IREDELL COUNTY HEALTH DEPARTMENT

Statesville Office (704) 878-5305 Mooresville Office (704) 660-3625 PERMIT # 223096

SEPTIC IMPROVEMENT PERMIT / AUTHORIZATION TO CONSTRUCT / OPERATION PERMIT / EXISTING SYSTEM

BL&D	Benfield Landscape & Design	CLIFF AND JULIE SWINGER	LOT 104 FERN HAVEN MOORESVILLE, NC IREDELL COUNTY

LOT 104 FERN HAVEN

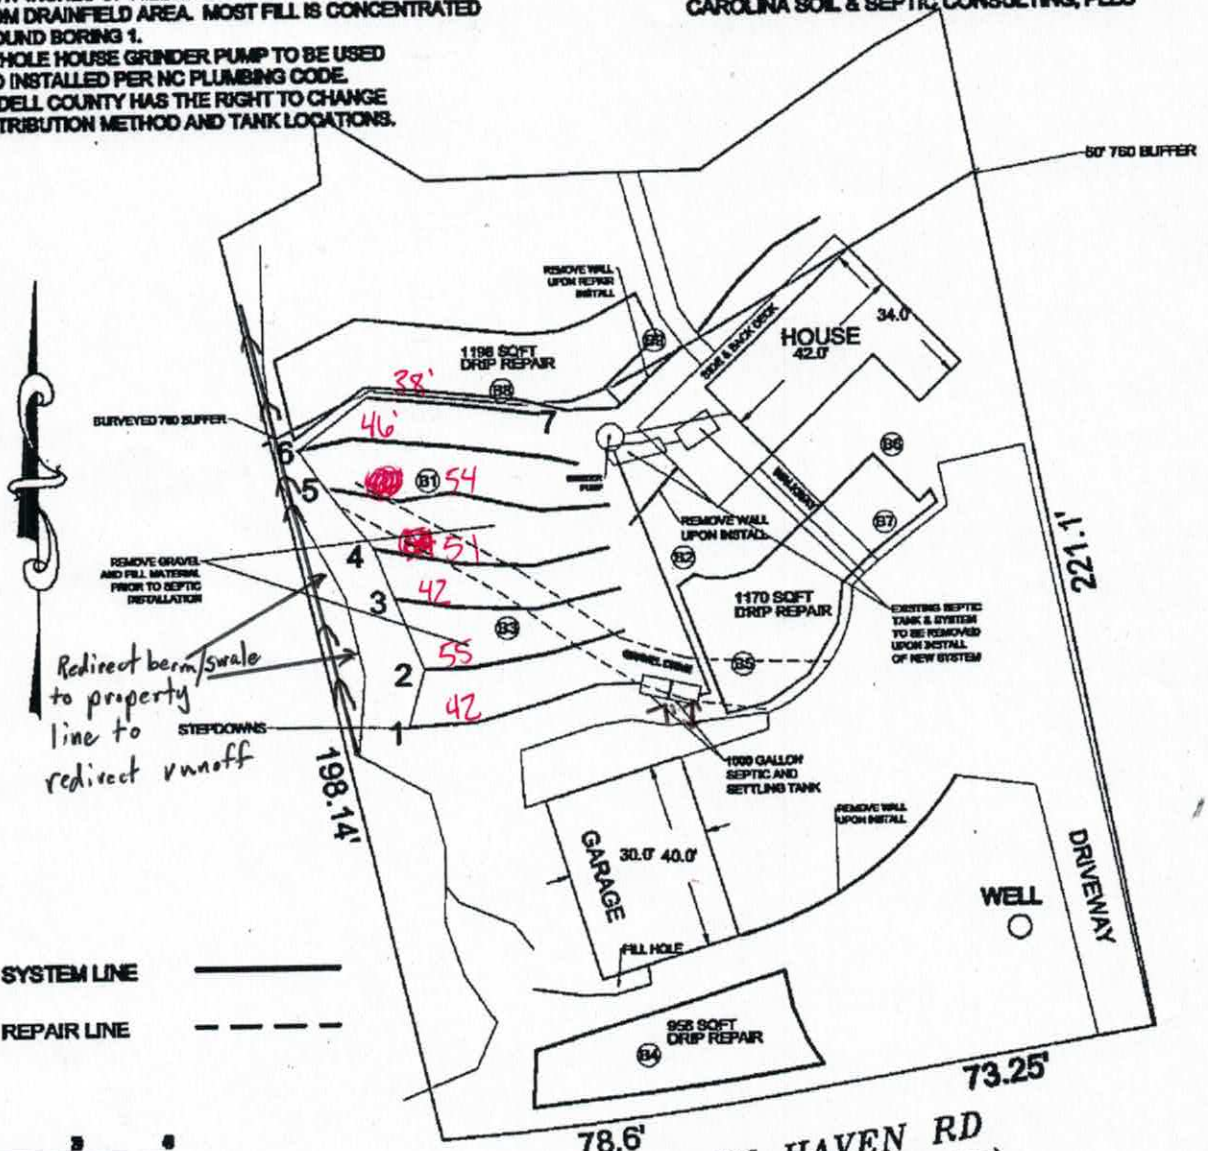
Comments / Conditions: Whole-house ejector pump requires 2 septic tanks in a series. Recommend a larger grade filter on outlett tee of 2nd septic tank. Recommend pumping both tanks every 5 years. Existing septic tank to be pumped + crushed in place. Re-direct swale/berm to property line to ensure proper offsets.

DRAIN LINES MEET SETBACK FOR BASEMENT UNDER DECK BA
